March 24, 2023

Subject: Asma Parcel Comprehensive Plan Amendment & Rezoning
Response to Comments dated 10/26/2022

The Town has received an application for a 0.69-acre parcel at the corner of SR-19 and Citrus Avenue to permit commercial development of the parcel. Based on the land use classifications contained in the Town’s comprehensive plan and the zoning categories consistent with those land use classifications, the applicable land use classification is Neighborhood Commercial, and the appropriate zoning is neighborhood commercial. The following comments are based upon the application of these land use and zoning designations to the project site.

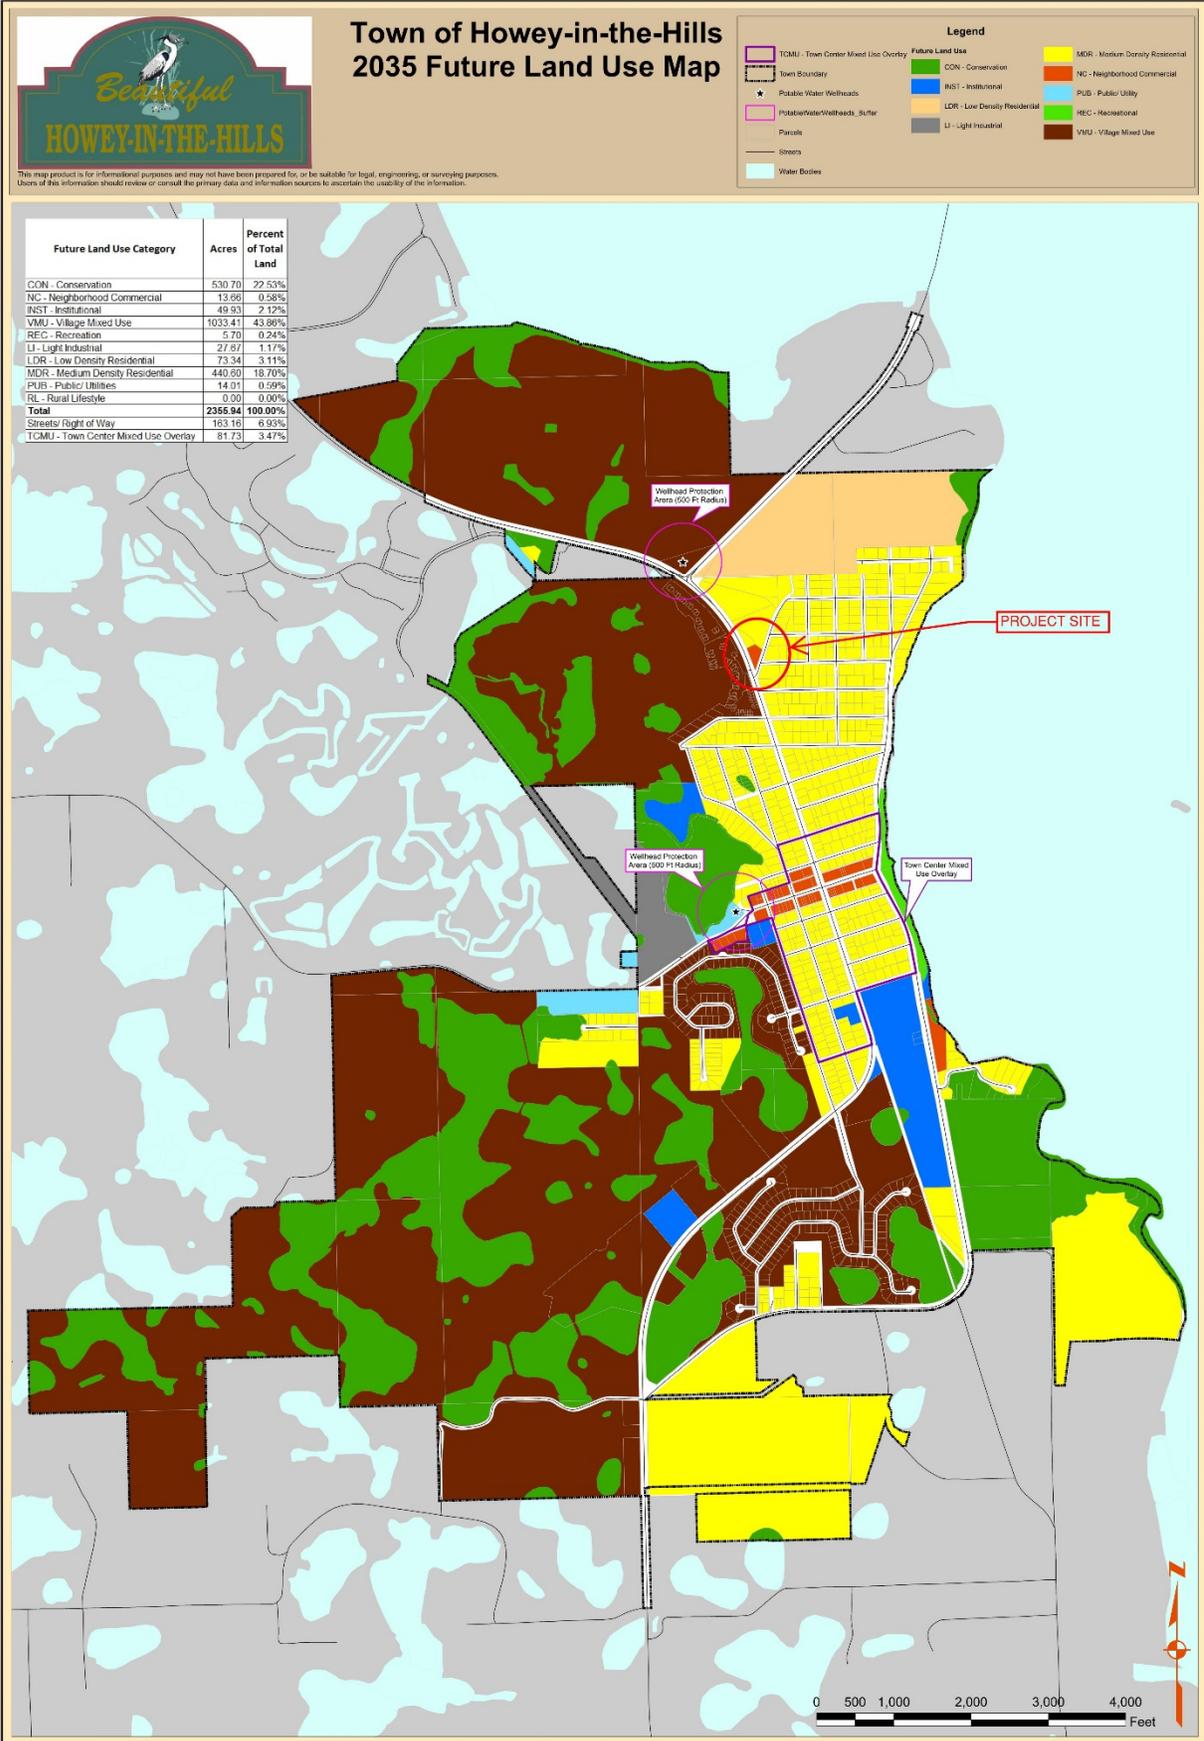
- Tree protection is an important component of development in Howey. The concept plan shows impacts to a twin 18-inch oak and a 36-inch oak. These trees need to be preserved on site unless they are diseased or otherwise unsuitable for protection.

- The plan shows 18 parking spaces including two handicapped spaces. The code requirement for the proposed building size is 13 parking spaces including one handicapped space.

- The plan shows the entrance driveway extending to the northern edge of the parcel. Unless there is some compelling reason to extend the driveway to the adjacent parcel, the driveway can be reduced to serve just the parking area.

- Buffers are shown on the conceptual site plan as required by Section 7.02.02 of the land development code. Buffers are shown at the correct dimension except for the north property line. The buffer is shown as 10-feet but 15-feet is required as the adjacent property is designated as residential use.

Response: Noted. We will work with an arborist to confirm whether the trees are in fact healthy and suitable for protection and revise the conceptual site plan, if needed, during the site development plan stage and prior to any physical site work.

Response: Noted.

Response: Noted. We will update our plan to provide a drive aisle only to serve the on-site parking area.

Response: Noted. The conceptual site plan will be updated to provide a 15' buffer on the north property line as requested.
